## Education Center at the Wall

June 1, 2015  
Project Report  
Vietnam Veterans Memorial Center – Education Center at the Wall  
National Capital Planning Commission

APRIL 2014  
COMMISSION OF FINE ARTS - COMMENTS

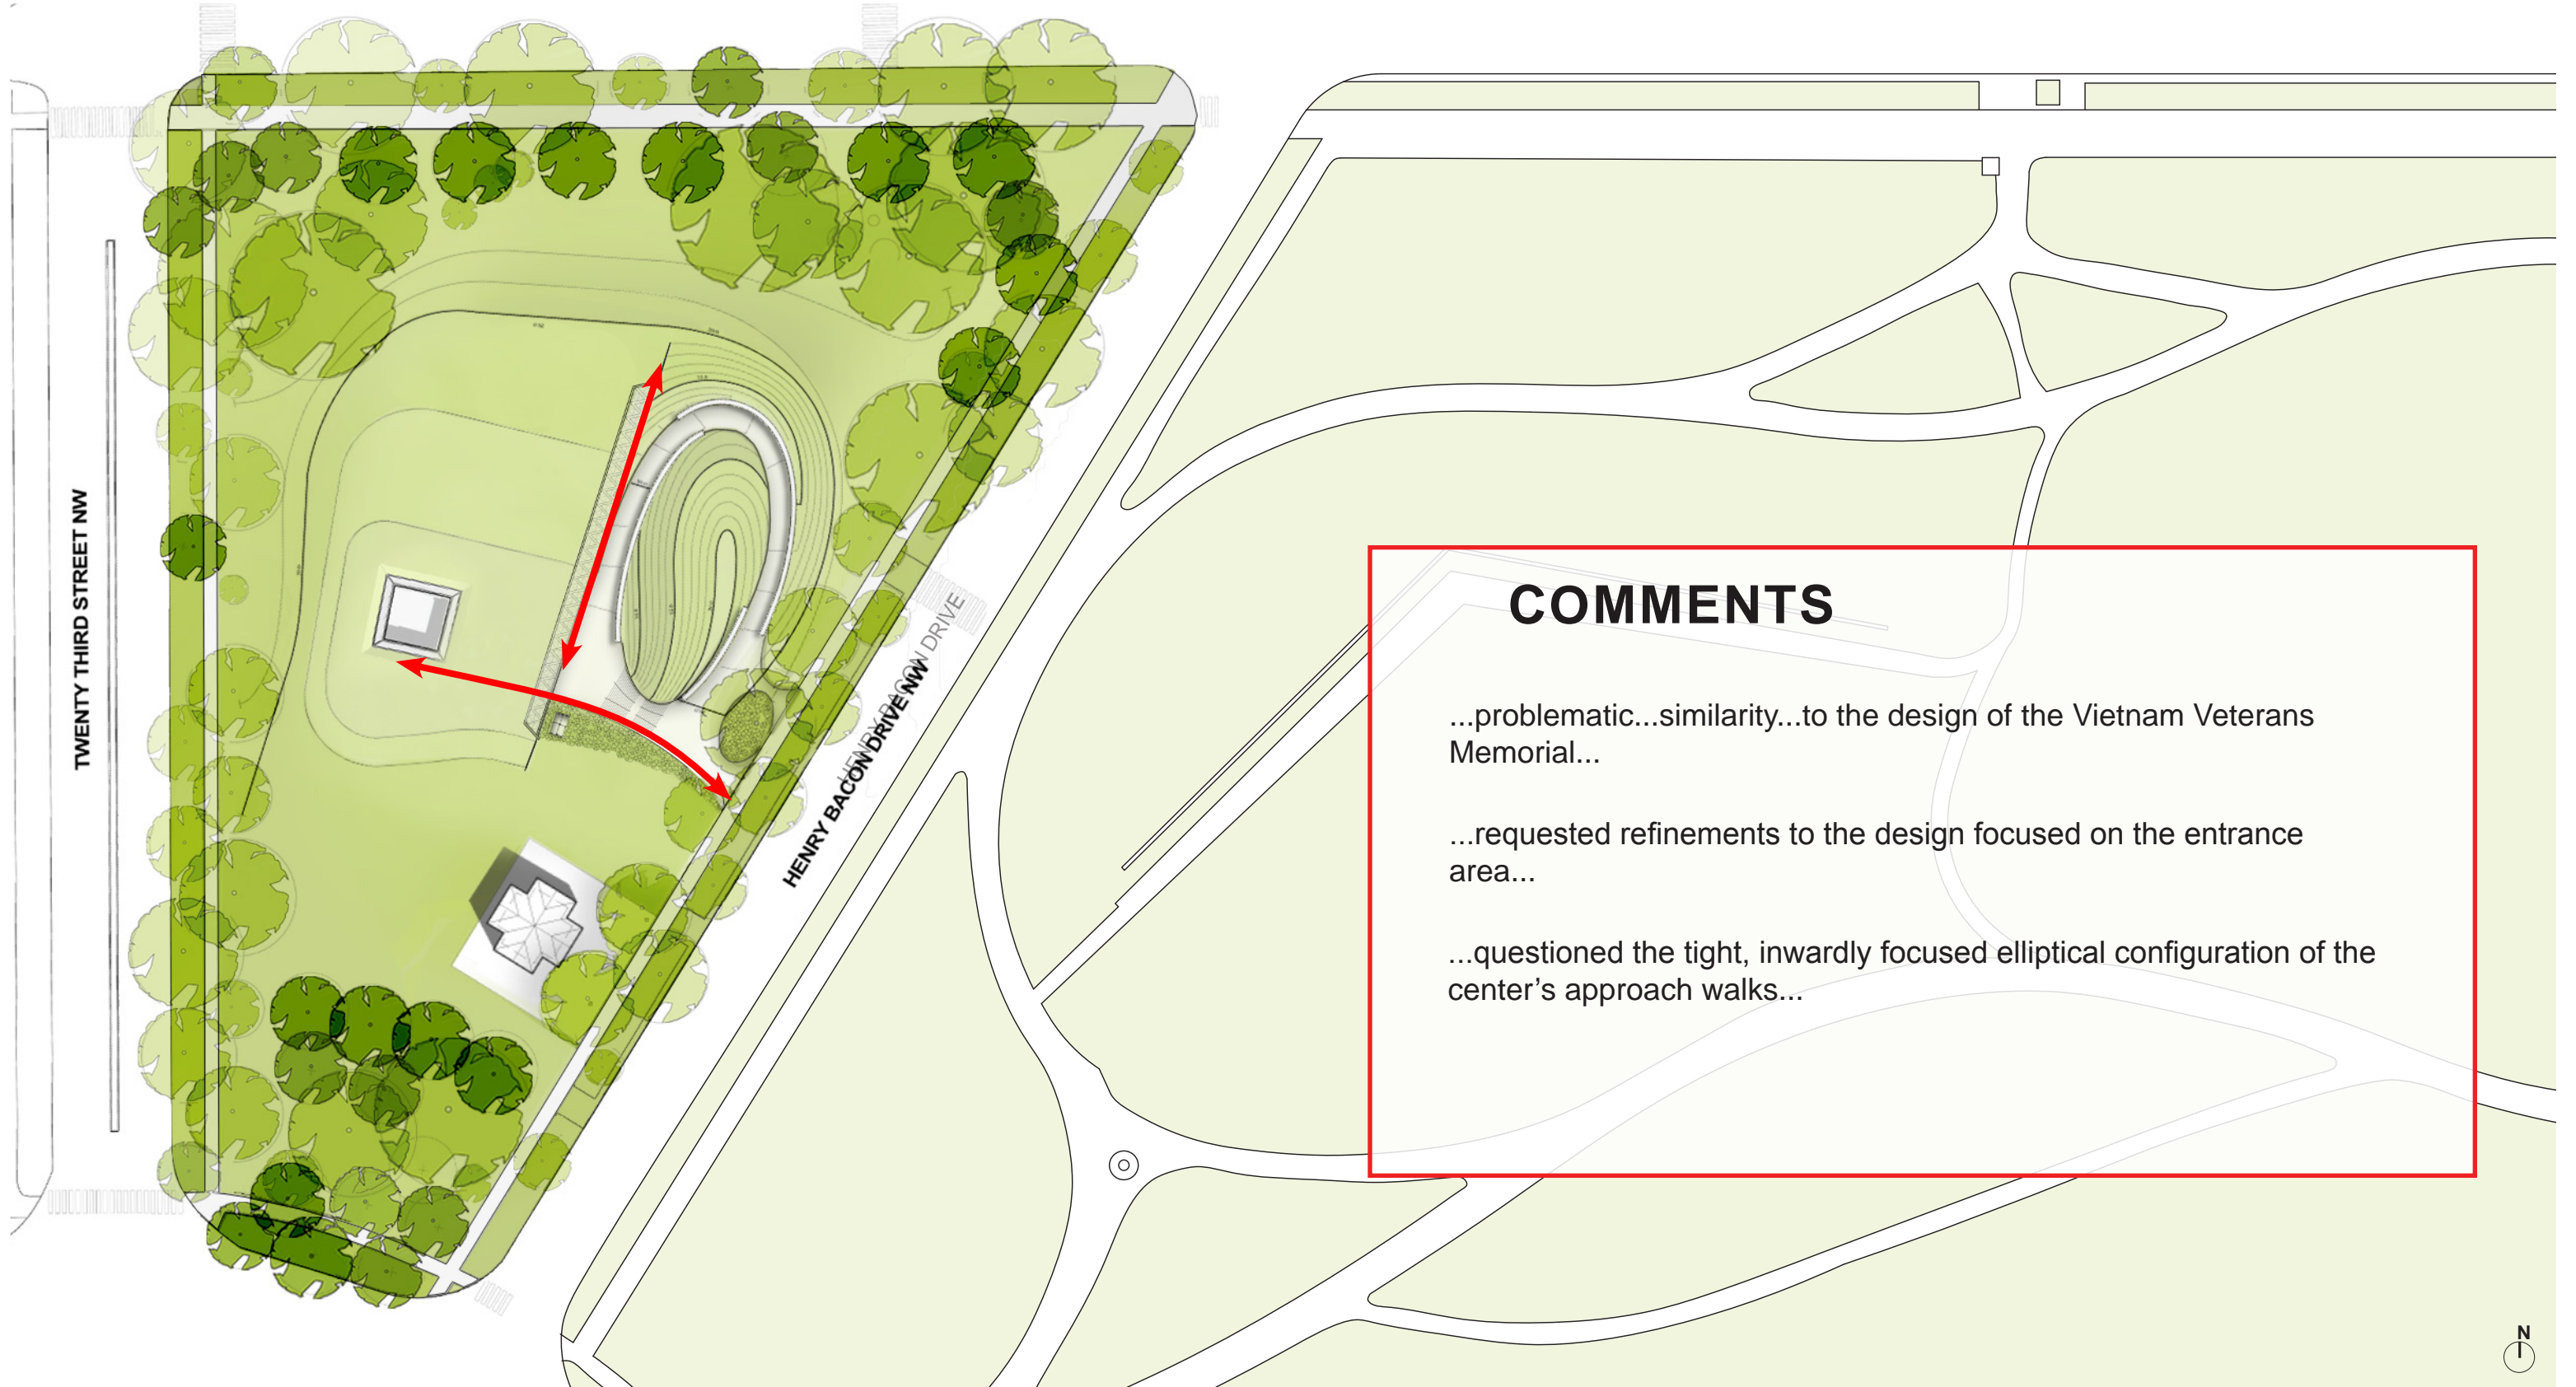
...problematic...similarity...to the design of the Vietnam Veterans Memorial...

...requested refinements to the design focused on the entrance area...

...questioned the tight, inwardly focused elliptical configuration of the center's approach walks...

APRIL 2014  
COMMISSION OF FINE ARTS - COMMENTS

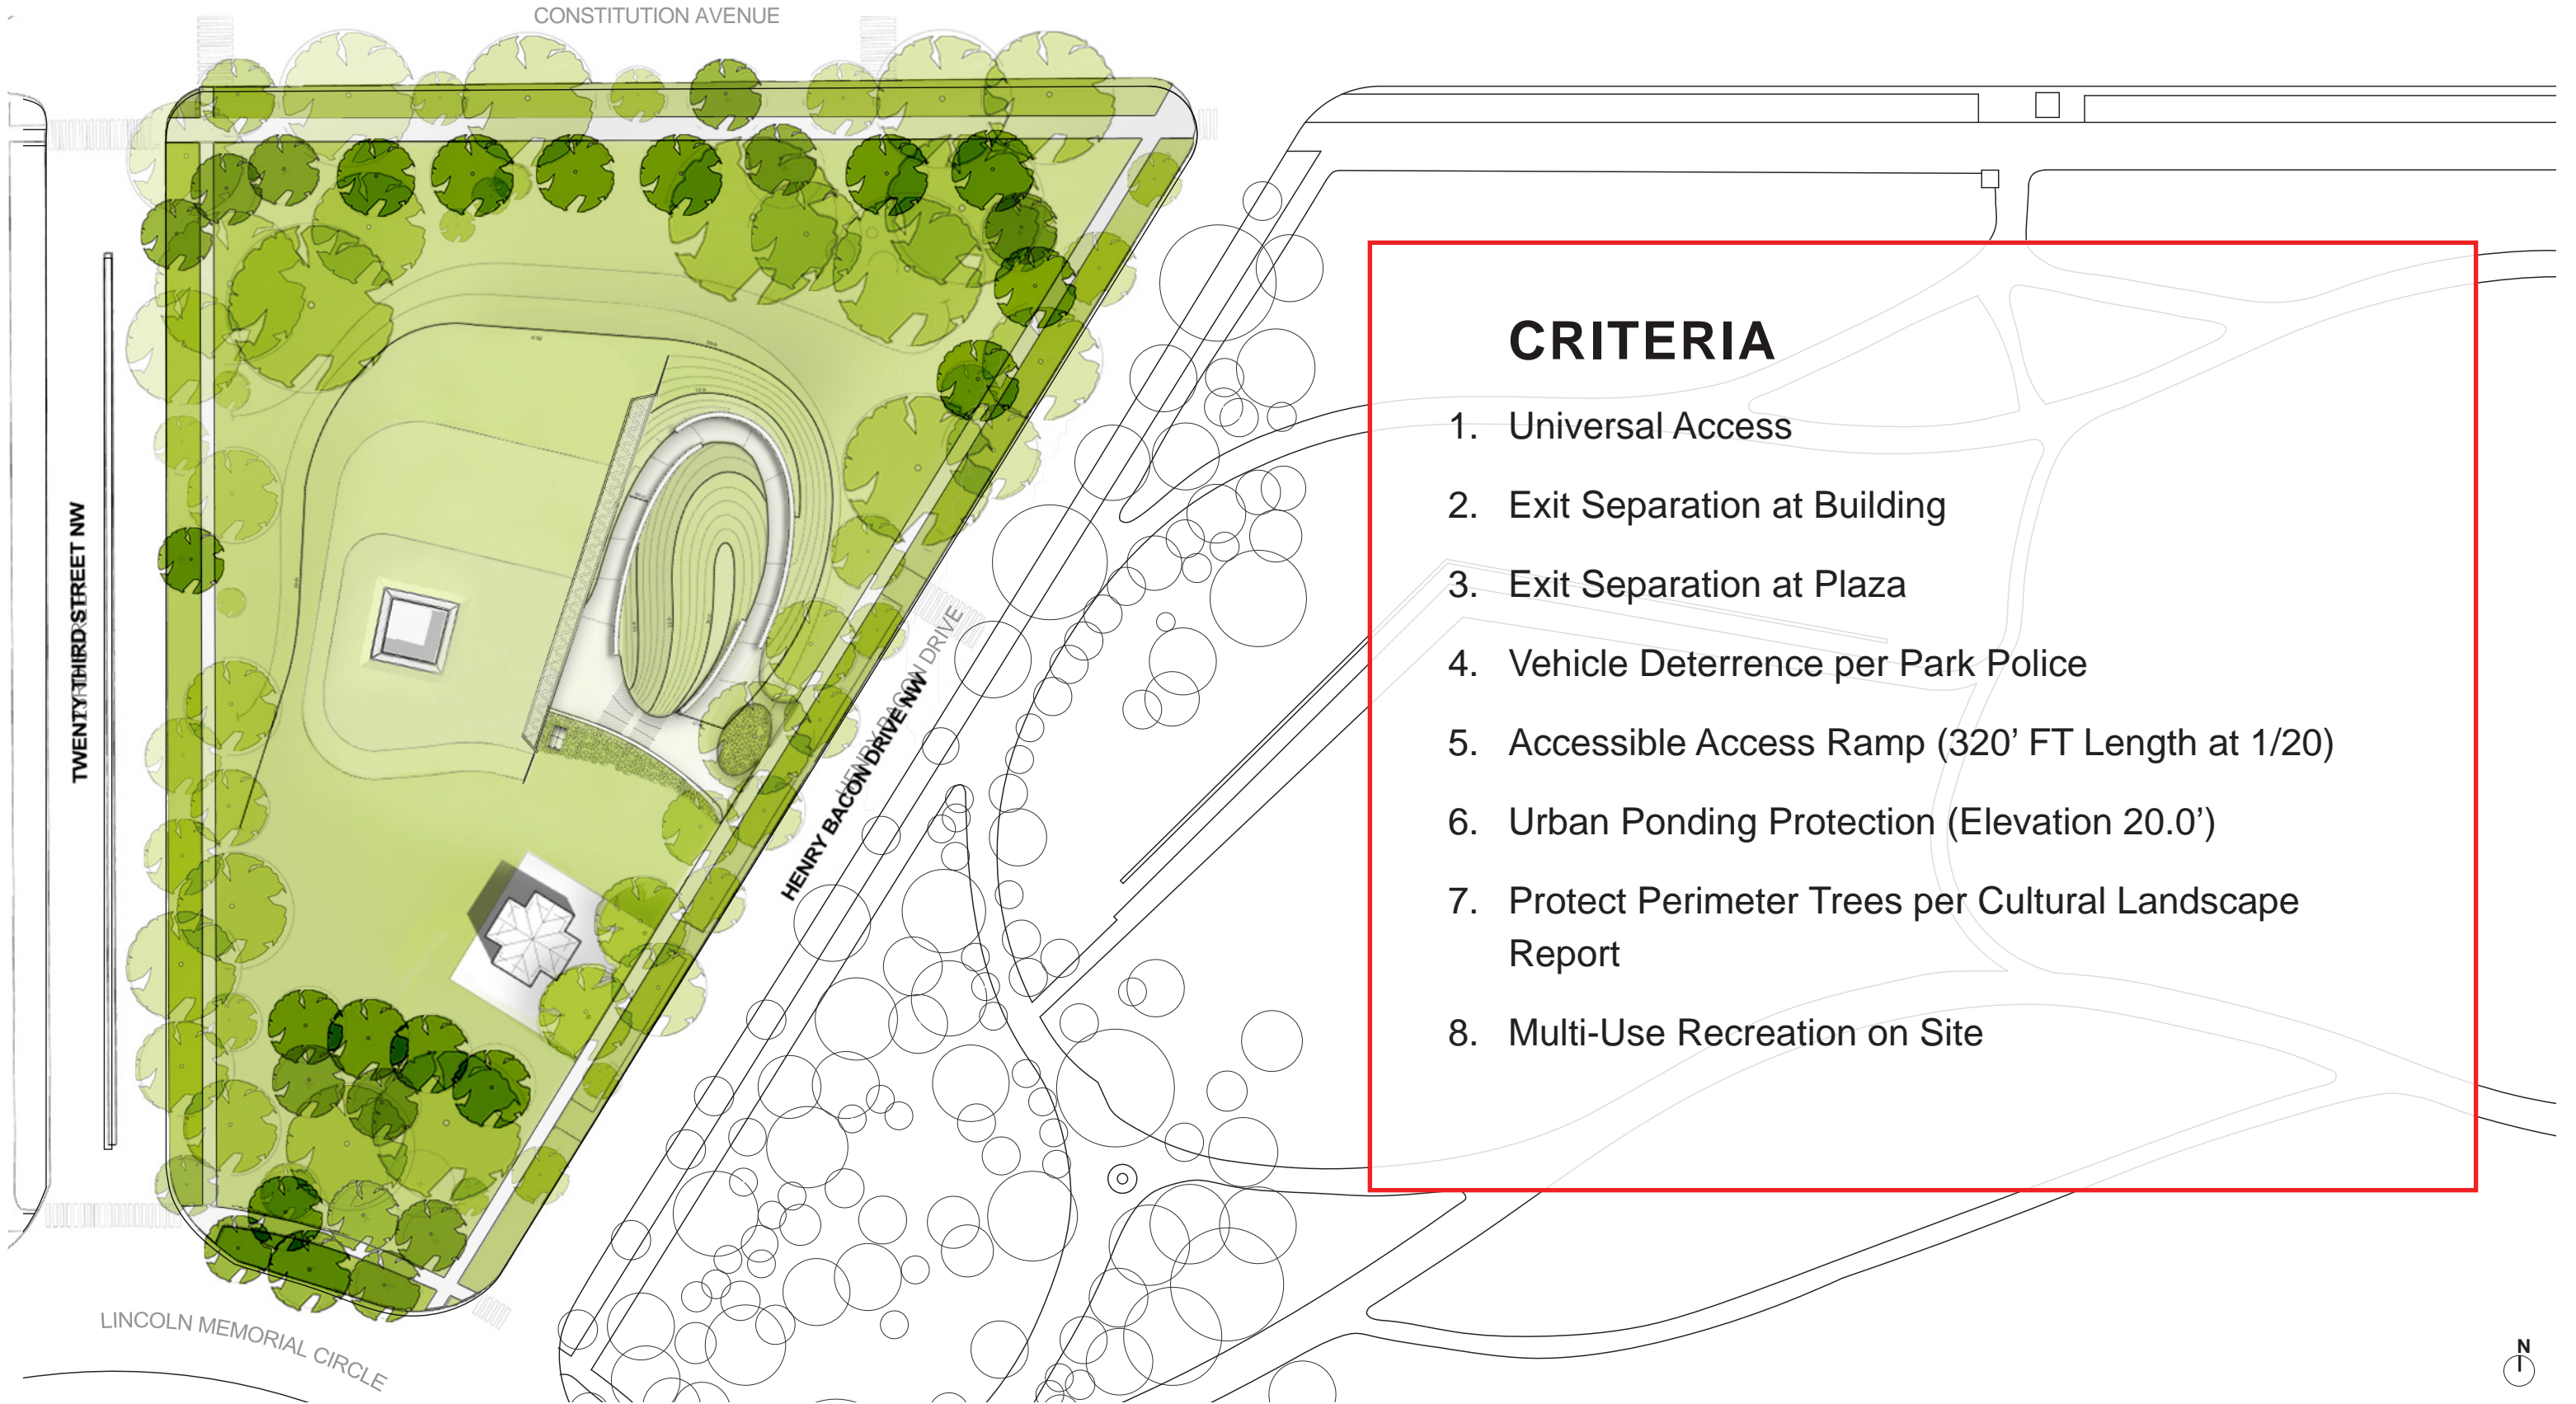
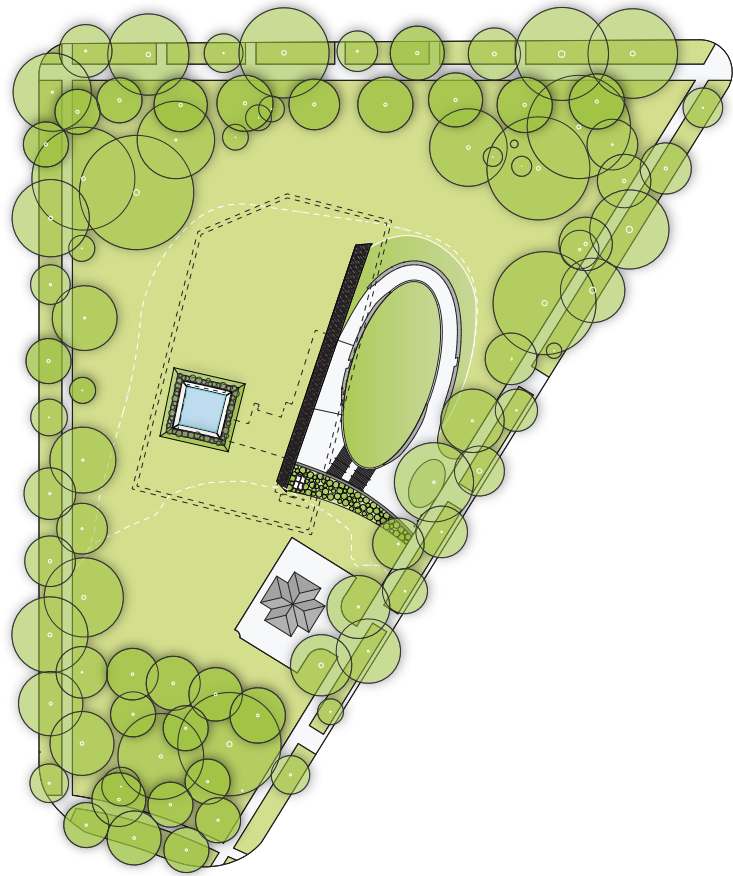
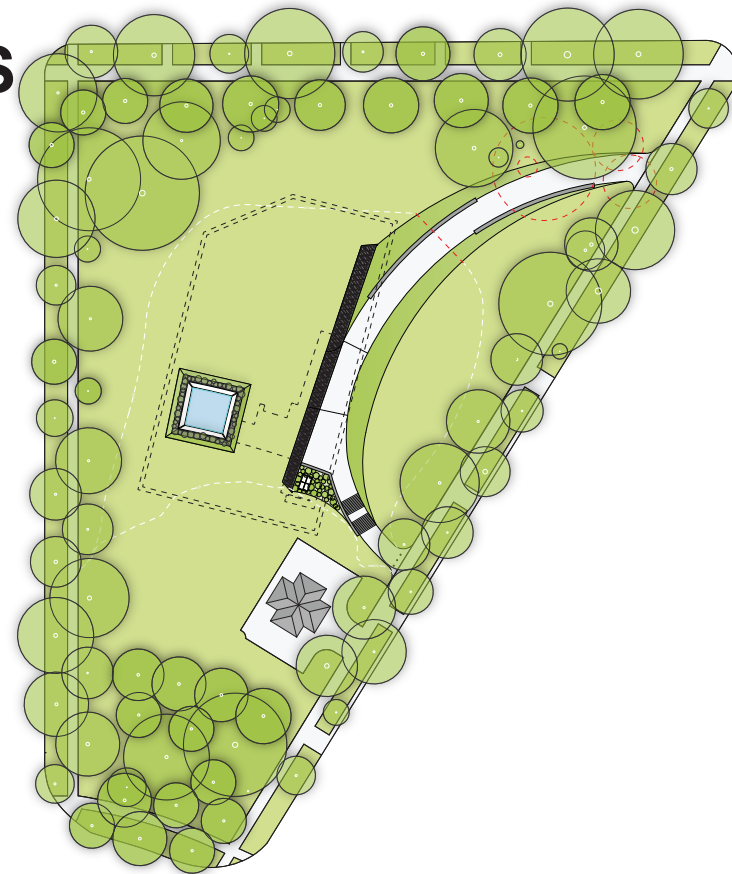
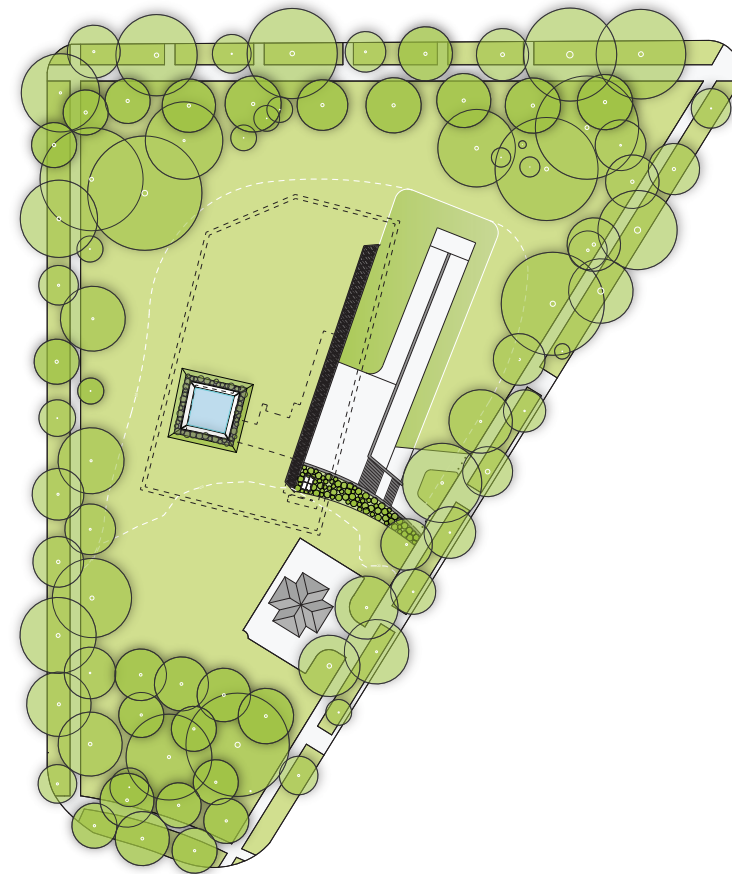
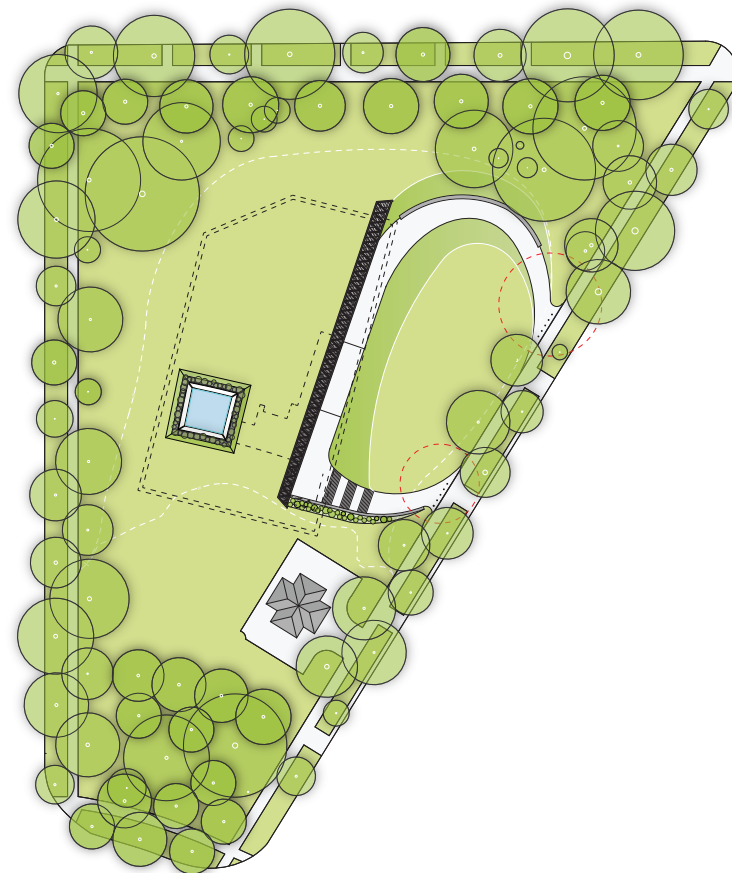
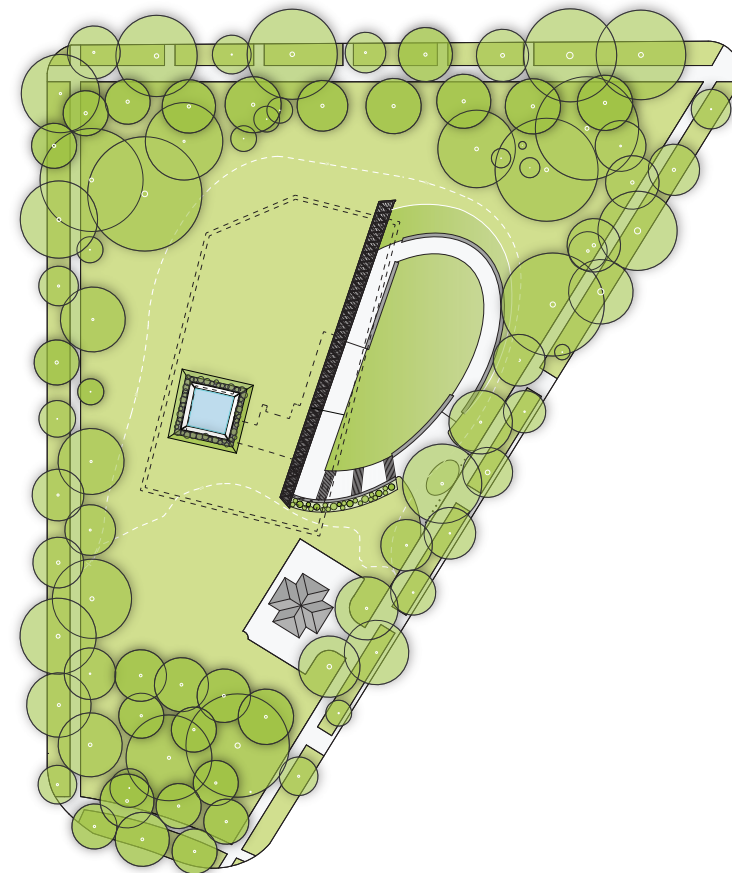
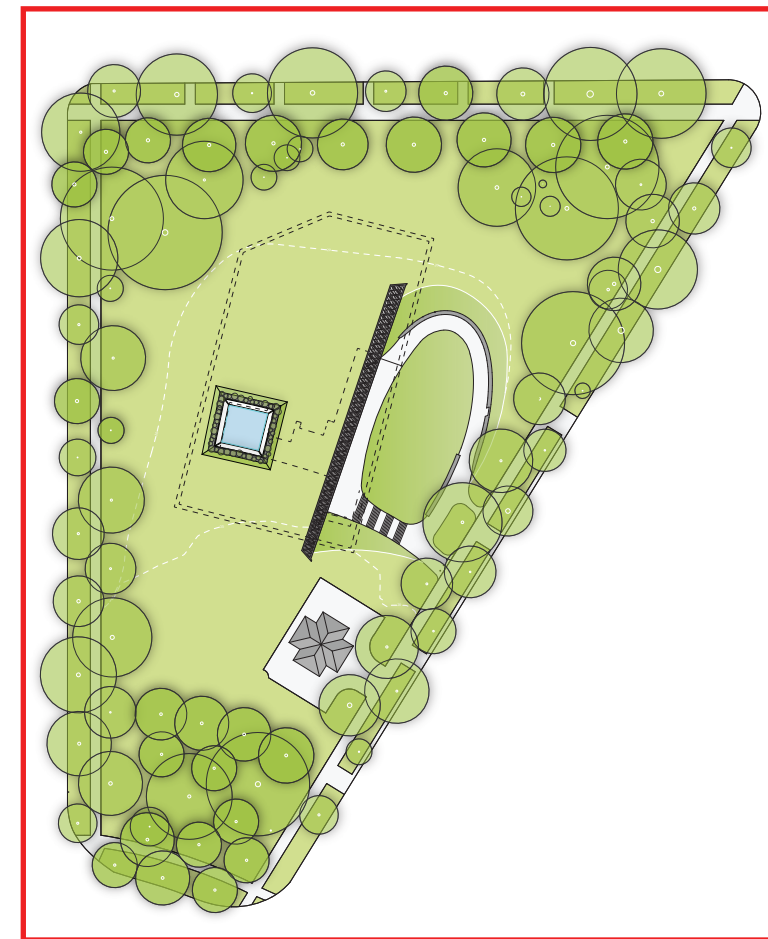
1. Universal Access
2. Exit Separation at Building
3. Exit Separation at Plaza
4. Vehicle Deterrence per Park Police
5. Accessible Access Ramp (320' FT Length at 1/20)
6. Urban Ponding Protection (Elevation 20.0')
7. Protect Perimeter Trees per Cultural Landscape Report
8. Multi-Use Recreation on Site

**RECONSIDERED DESIGN**
